**SITE PLAN REVIEW SHEET
ENVIRONMENTAL VARIANCE REQUEST ONLY**

CASE: SP-2019-0253C

PROJECT NAME: Springdale Farms

Staff Findings of Fact
Variance to LDC 25-8-261

Proposed Encroachments

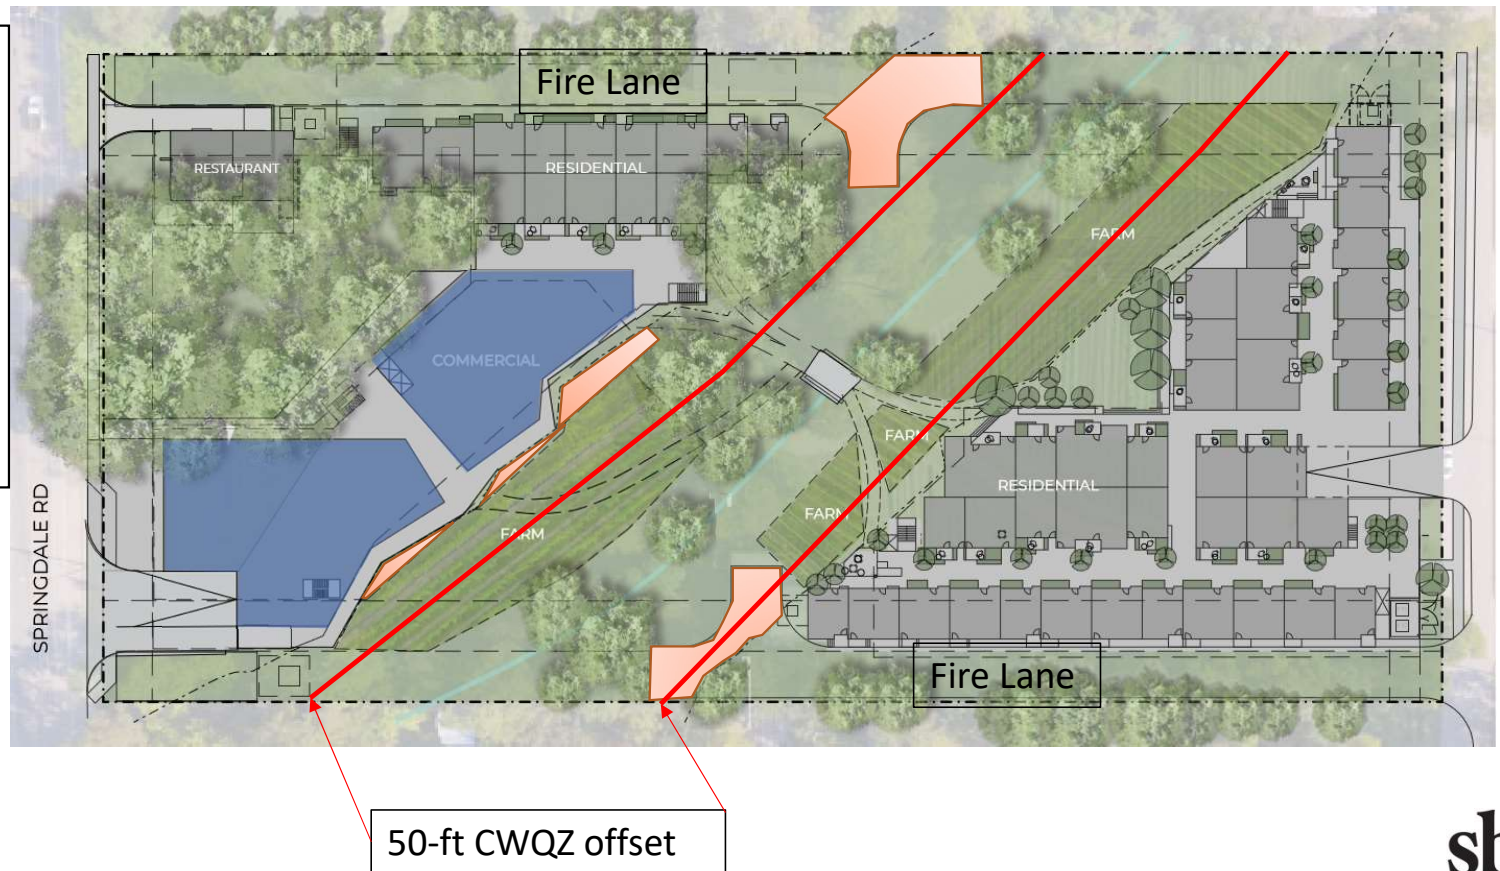
No Due to the scale of the project to maximize development, the applicant has made a design choice to make use of the CWQZ to address Austin Fire's code requirement for the hammerheads, which are not allowed by the Land Development Code. Moreover, to increase building square footage, there will be building overhangs over the CWQZ, creating rain shadow effect that would deprive the CWQZ of necessary rainfall and sunlight. The scale and design decisions do not provide greater overall environmental protection. See Exhibit 1 – Overall Proposed Site Plan.

- No In addition to the building overhangs within the CWQZ, the hammerheads encroach on both sides of the CWQZ. Development is prohibited within the CWQZ except as provided in LDC 25-8-261 which doesn't include the stated development, thus requiring the need for a variance from the Land Development Code.

- c) Does not create a significant probability of harmful environmental consequences.
- No The building overhangs and hammerheads within the CWQZ would deprive the CWQZ of rainfall and sunlight penetration that are necessary for riparian health, and adding impervious cover and development to the CWQZ where there wouldn't be otherwise. Furthermore, there would be removal of native vegetation and topsoil.

- 3. Development with the variance will result in water quality that is at least equal to the water quality achievable without the variance.
- No There would be impervious cover and development within the CWQZ where there wouldn't be otherwise. The impervious cover from the building overhangs would not be draining to the water quality pond.

- Approximately 3500 SF of “Grass-Crete” permeable paving system within Floodplain/CWQZ with only 1200 sf being within the initial 50-ft offset to serve as Fire access
- Approximately 800 SF of building overhang into proposed urban farm area (max overhang: <5')
